VILLAGE OF TWIN LAKES

PLAN COMMISSION MEETING

WEDNESDAY, JANUARY 18TH, 2023 at 6:30pm
VILLAGE HALL

TO: Plan Commission Members
FROM: Bonnie Schaeffer, Zoning Administrator
RE: Gartenberg – 301 W. Park Ave. Request to Construct a Residence
DATE: January 12, 2023

GRADING PLAN

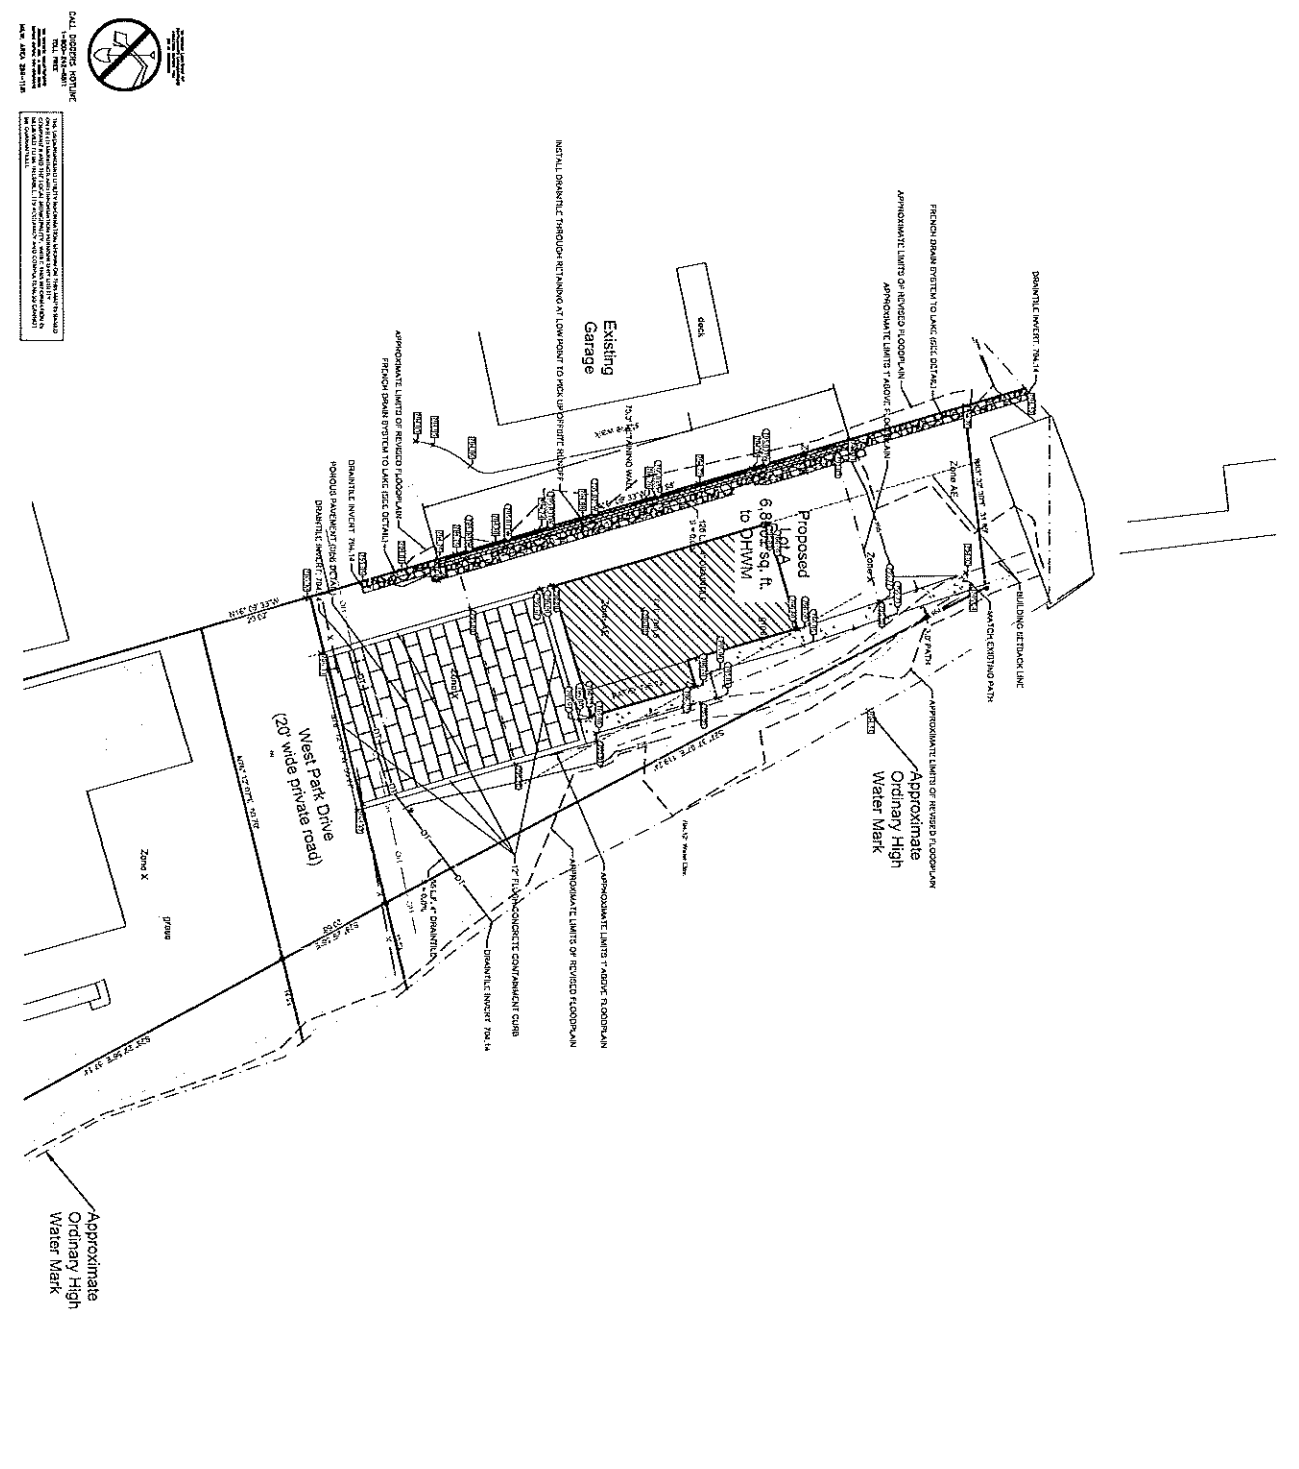
It is my understanding that the applicant is requesting to build a residence on the part of their parcel with water frontage on Lake Mary and on the channel. They are asking for approval to either split the lot or to allow two principal structures on one lot.

- The applicant is requesting a 12.5' setback to the channel.

Per 17.39.070.A

No principal structure, as defined in the underlying basic use District, in the Shoreland Protection Overlay District shall be located closer than sixty (60) feet to the OHWM of a navigable lake, channel or stream. This setback may be reduced to the average of the setback of the principal structures on the adjoining improved properties upon design, timely installation and continued maintenance of a fifteen (15) foot vegetative buffer on the premises of a design and maintenance plan acceptable to the Village. Installation of the buffer shall be secured by a bond or cash escrow in sufficient amount to ensure installation. In no case may the shore yard setback for principal structures be less than twenty-five (25) feet. Upon installation and prior to return of the bond or escrow, a final photograph of the vegetative buffer shall be submitted to the Building Inspector.

- The applicant has not provided impervious surface calculations.

Per 17.39.070.C

The aggregate amount of impervious surface in the shore yard shall not exceed twenty percent (20%) of the total area of the shore yard.
